The City of Spartanburg Design Review Board

AGENDA

August 1, 2023, at 5:30 P.M.

The Design Review Board (DRB) has received a request for Preliminary conceptual approval of a buildings form, massing and placement on the site for the proposed Spartanburg County Public Library – Headquarters Expansion and Planetarium located in the DT Zone (Civic District) at 151 S. Church Street (Tax Map Sheet: 7-12-21-074.00). Owner: Spartanburg County Library / Applicant: Adam Flynn and Sarah Stevens, McMillan Pazdan Smith.
- IX. Selection of Chair / Vice Chair.**
- X. Staff Announcements:**

BLANK WALL IN EXCESS OF 20' - 0"

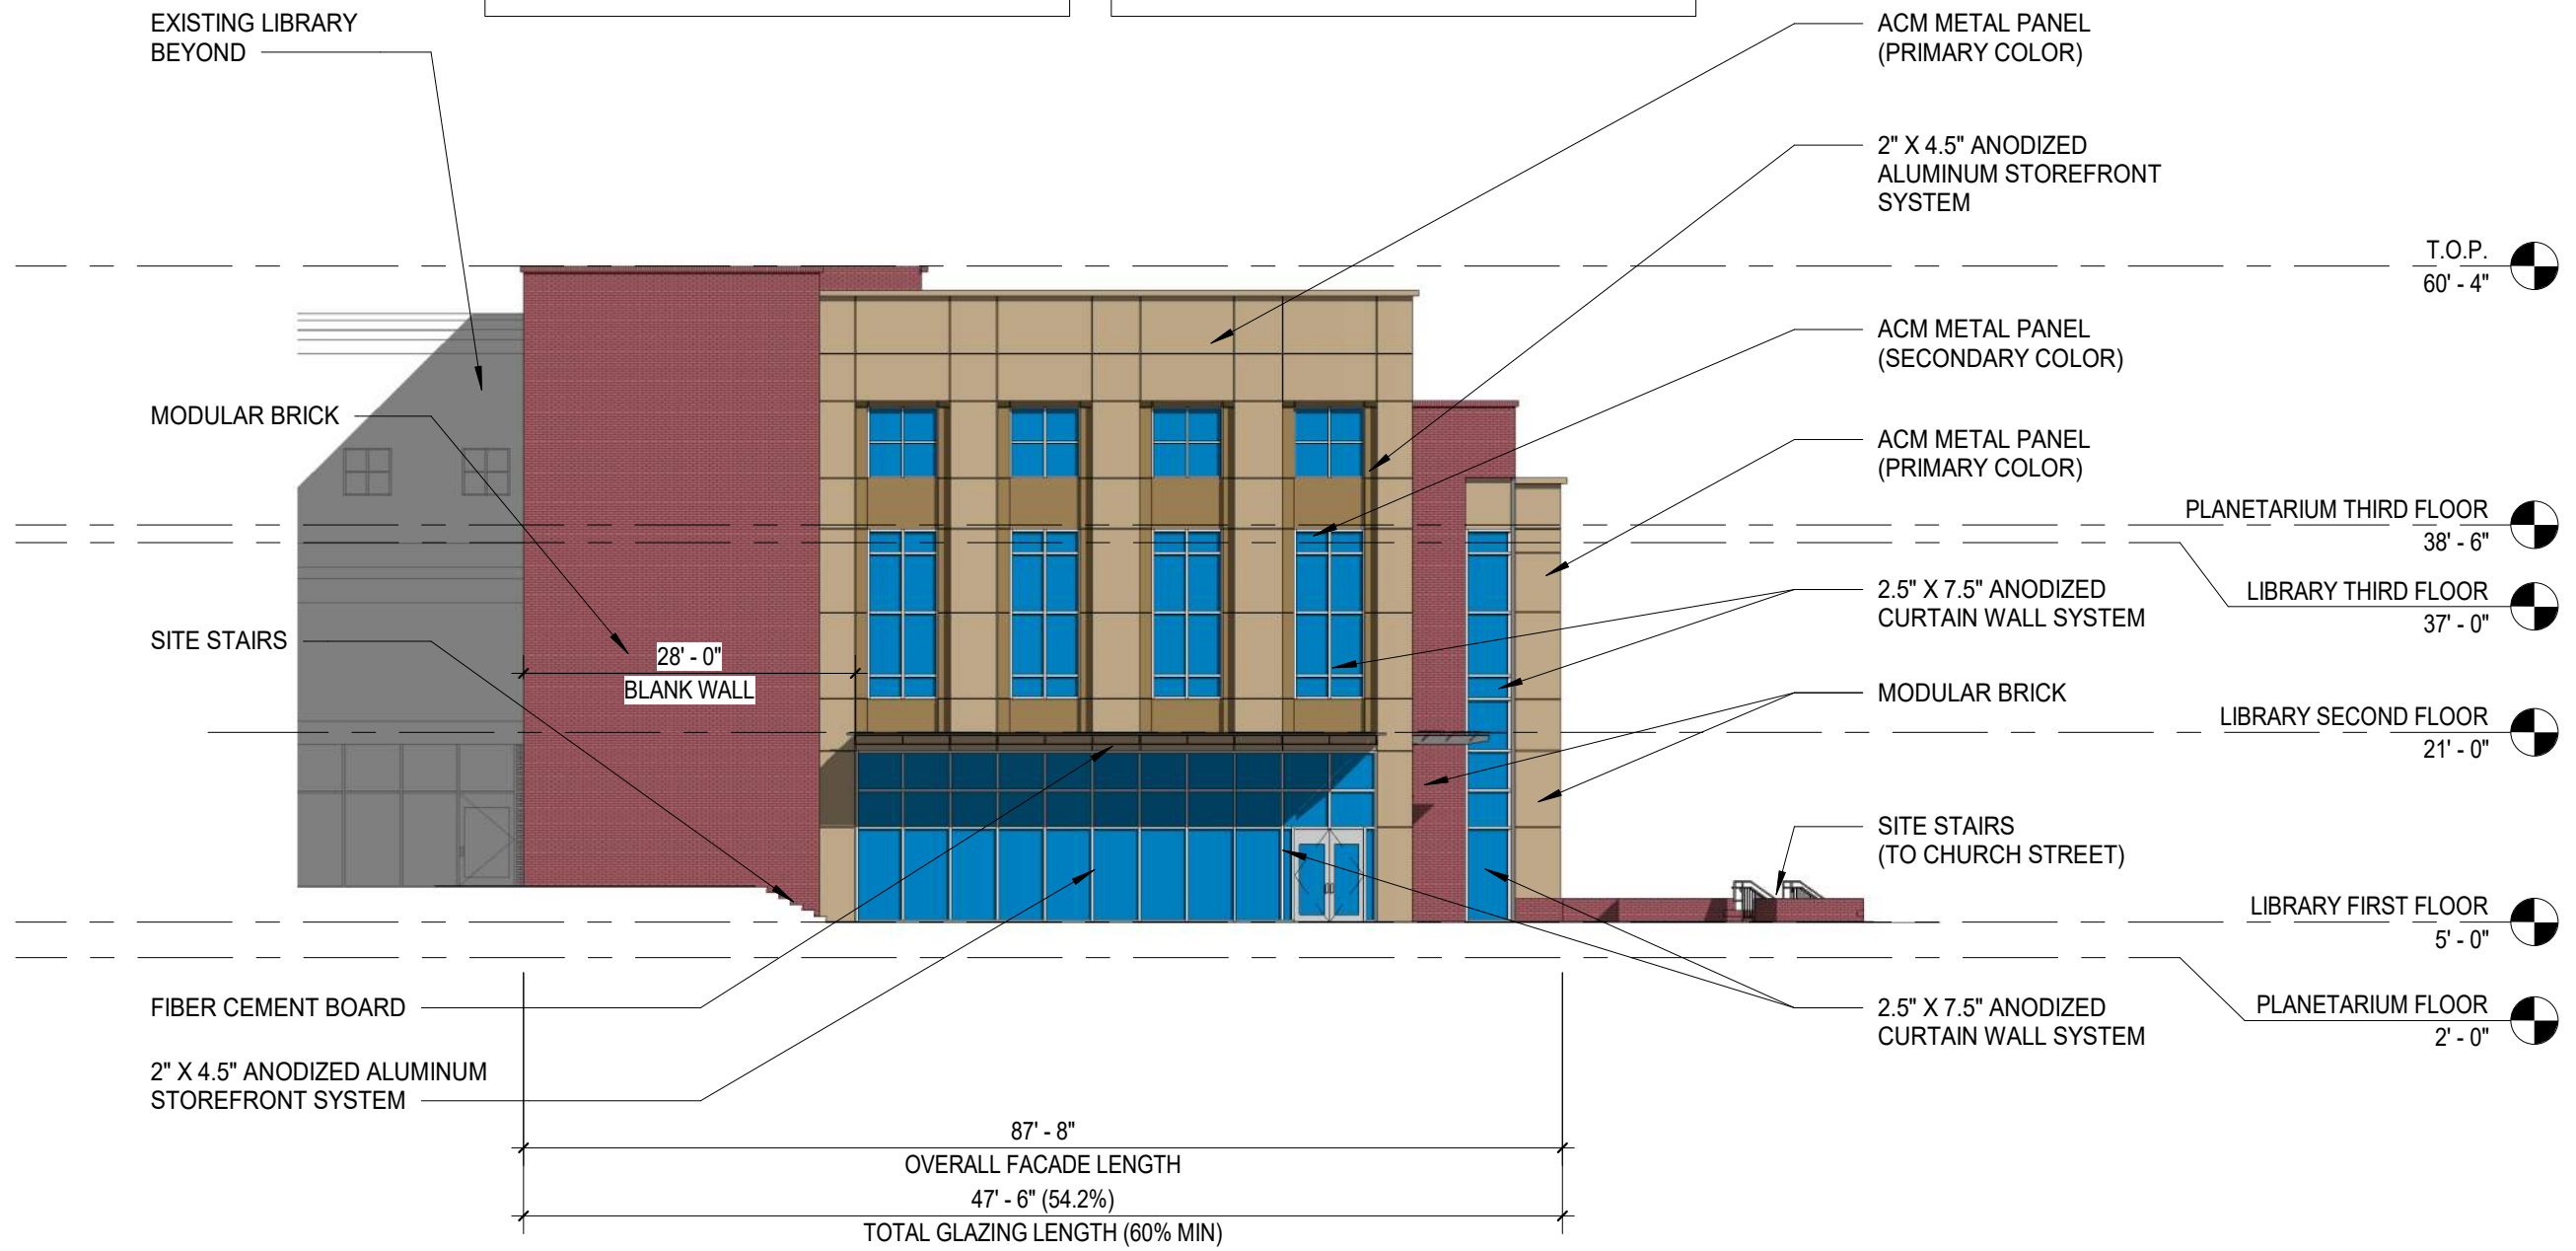
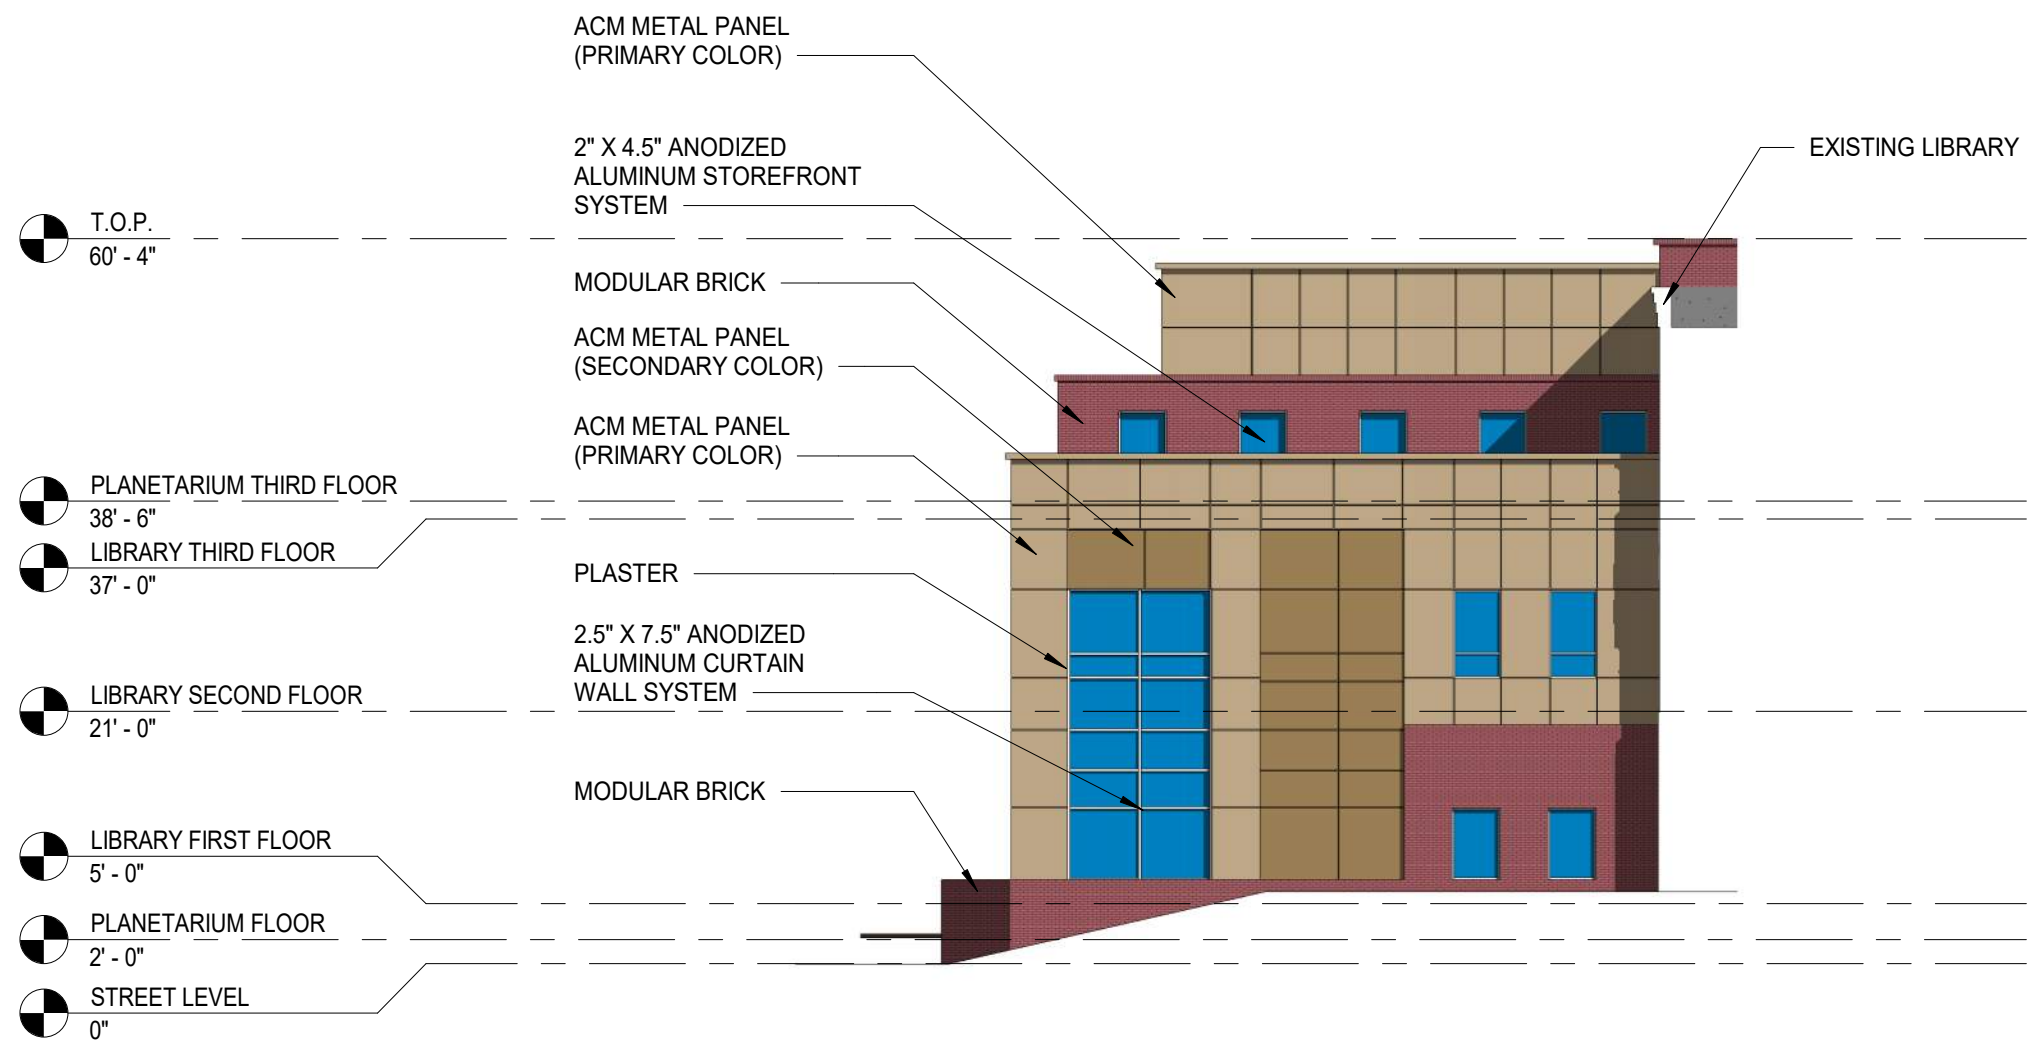
WE ARE PROVIDING A BLANK WALL THAT IS 28' - 0" WIDE FACING BROAD STREET TO ALLOW FOR LOADING ACCESS, REQUIRED EGRESS FROM THE UPPER LEVELS, AND TO CONTRAST AND ACCENT OUR CORNER ENTRY SEQUENCE.
